Sydney Olympic Park New High School

Architectural Response to SDRP Report

Interface with sports field

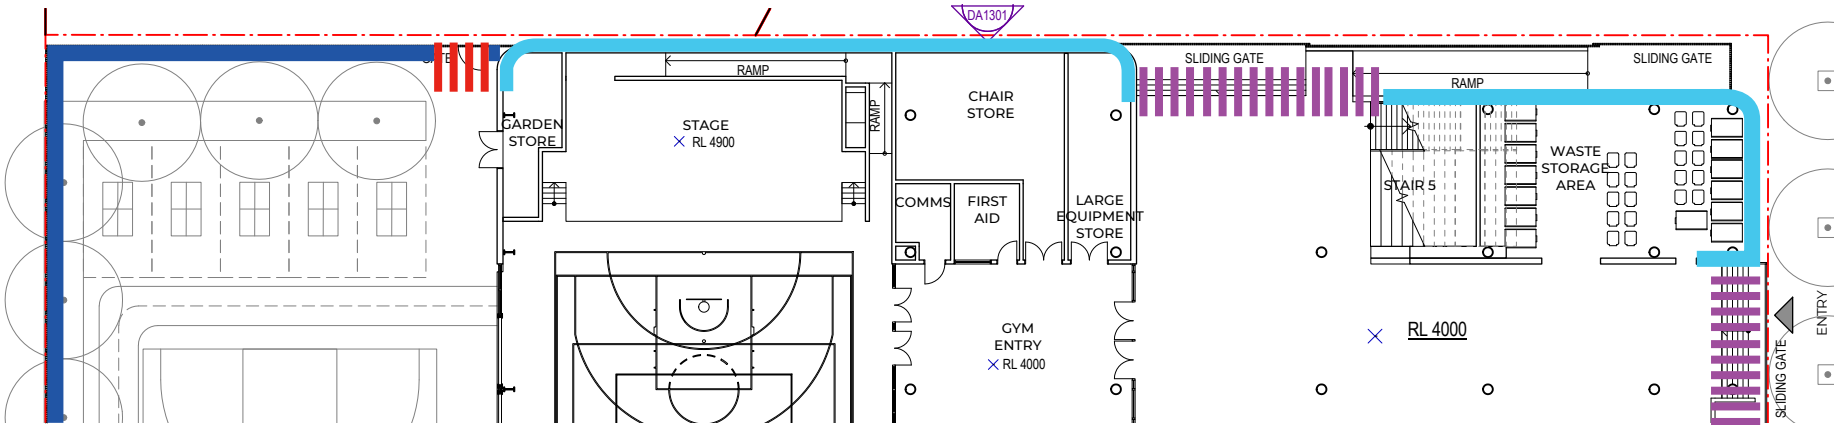
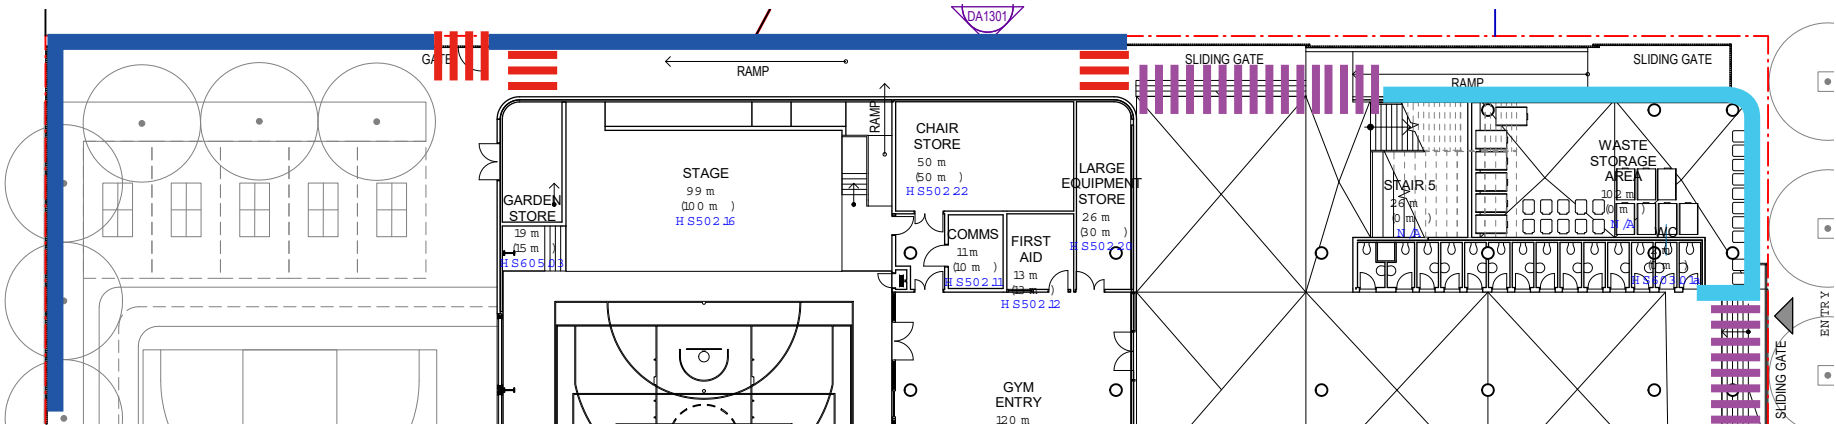
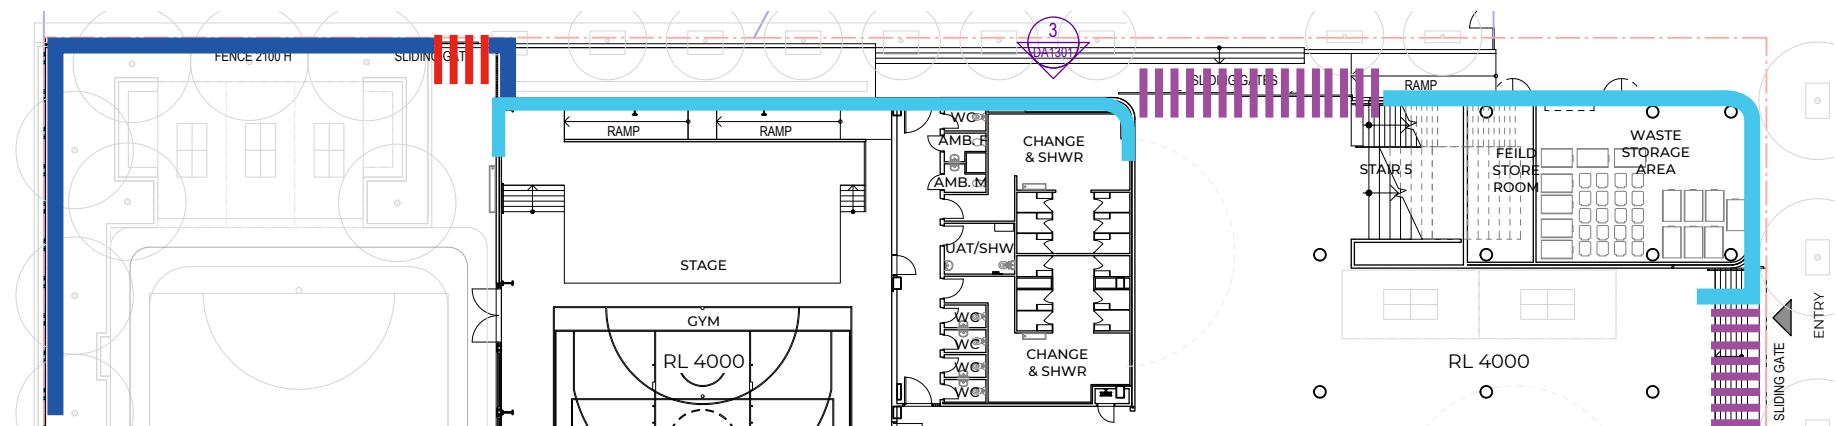
Comment: Sports field – Resolve the interface between the school grounds and the sports field to the north. Indicate the location, size and extent of fences and gates and opportunities for connectivity. Consider extending the perimeter planting along the northern setback of the hall.

The interface between the school and future sports field has been further developed in order to minimise the length of fencing required, allowing the building to mark the secure line where possible.

The design progression explained in the series of diagrams, show current resolution for the northern interface. The design response is to allow the northern walls of the gym and waste store to act as the school's secure line. Also noting the SDRP's suggestion, planting has been extended along this boundary, where appropriate.

The design of the gymnasium building has evolved to express the gym (to the west) and movement studio (to the east) as distinct elements. The movement studio and changerooms beneath it are marked by a brickwork facade, while the adjacent gym facade features a band of graffiti-resistant green glazed bricks at low level with an artwork wall above. What had previously been a large, unrelieved wall has now been given more definition and variation of materials, presenting a more engaged face to the sports field.

Interface with primary school

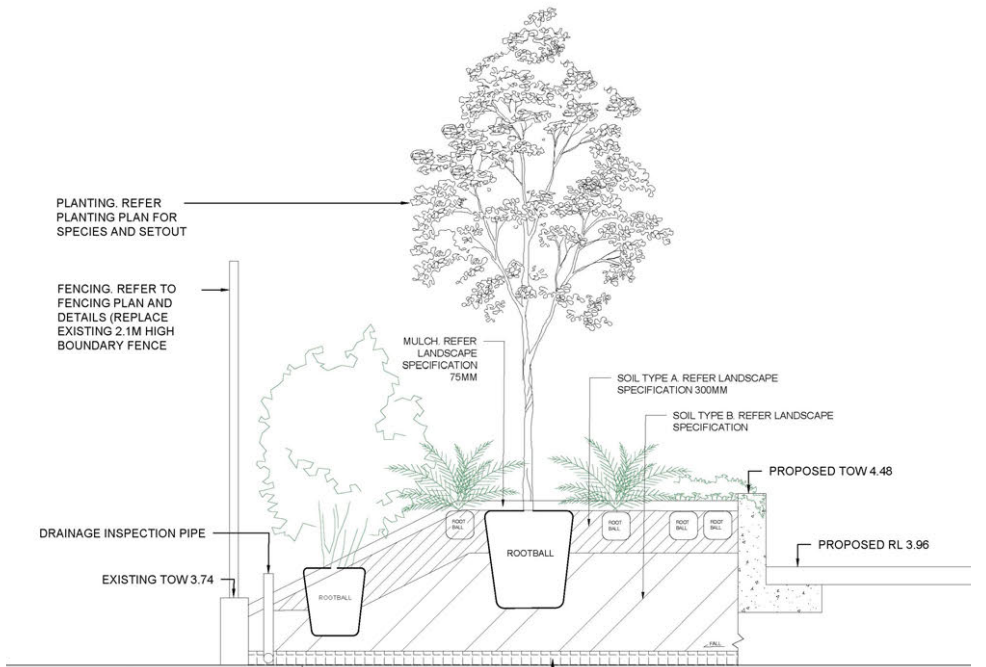
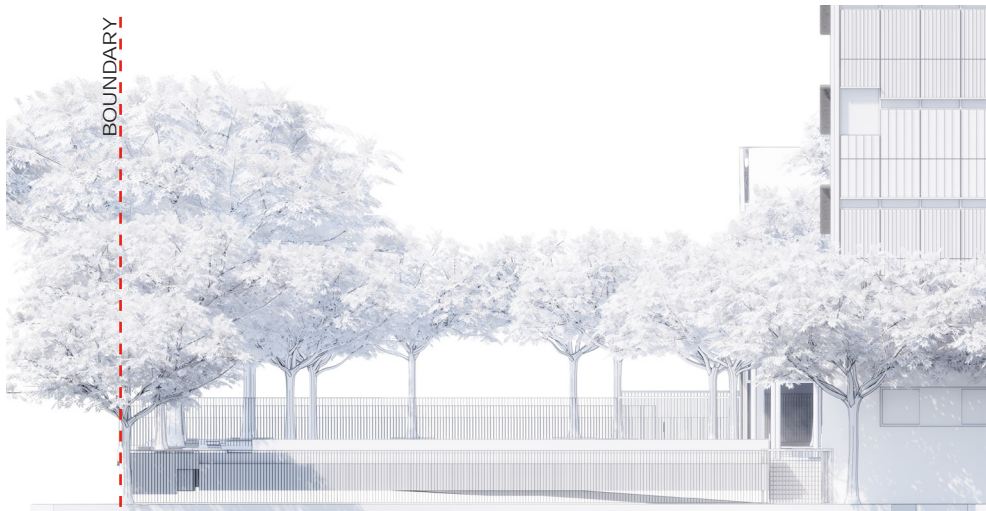
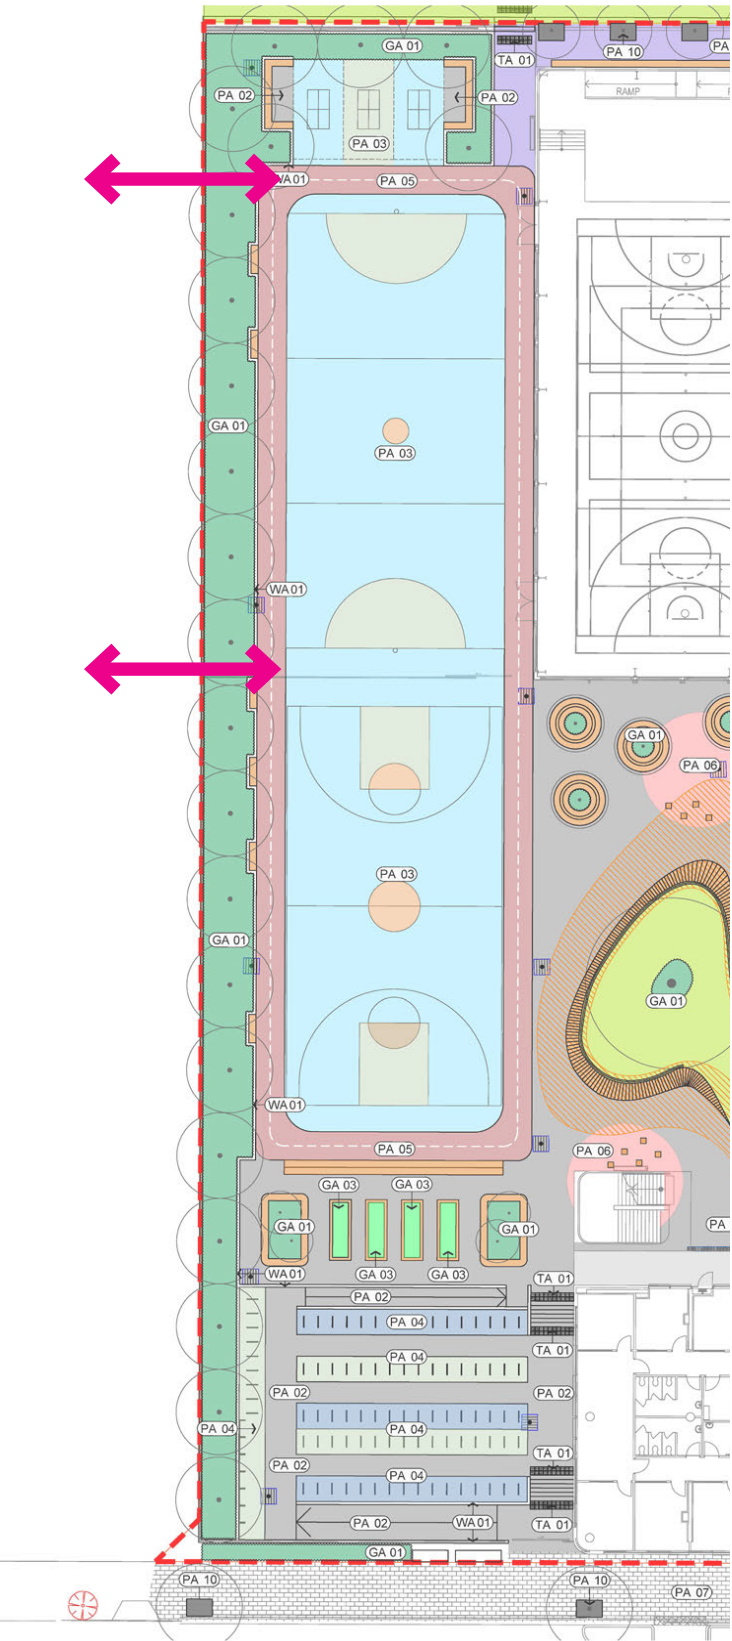
Comment: Public primary school - Consider the height, material and landscaping of the fence along the western boundary. Plan for and illustrate future connections, both visual and physical, with the adjacent public school.

The existing palisade fence along the western boundary with the primary school is to remain while still achieving the requirement to separate the two schools.

A 2.4m high Sportscourt fence has been added to the boundary and is integrated with a 3m wide garden bed with low planting between the fence and the sports court (Issue Item A3.5m - soften boundary to WPPS). Future connections are highlighted on the plan.

From the existing fence, a landscaped embankment rises gently up to meet a low retaining wall that marks the edge of the high school sports courts. This embankment smooths the transition of levels, and the retaining wall is set at a height to suit informal seating and will contain wayward balls from any sporting activity taking place.

In the future, the existing fence may be removed, or punctuated by gates to provide controlled access between schools. Such future connections are earmarked for two key locations: at the northern edge of the northern sports court, and between the north and south courts (on the southern side of the fence). Such alignments would allow movement between schools without interrupting games taking place on the courts.
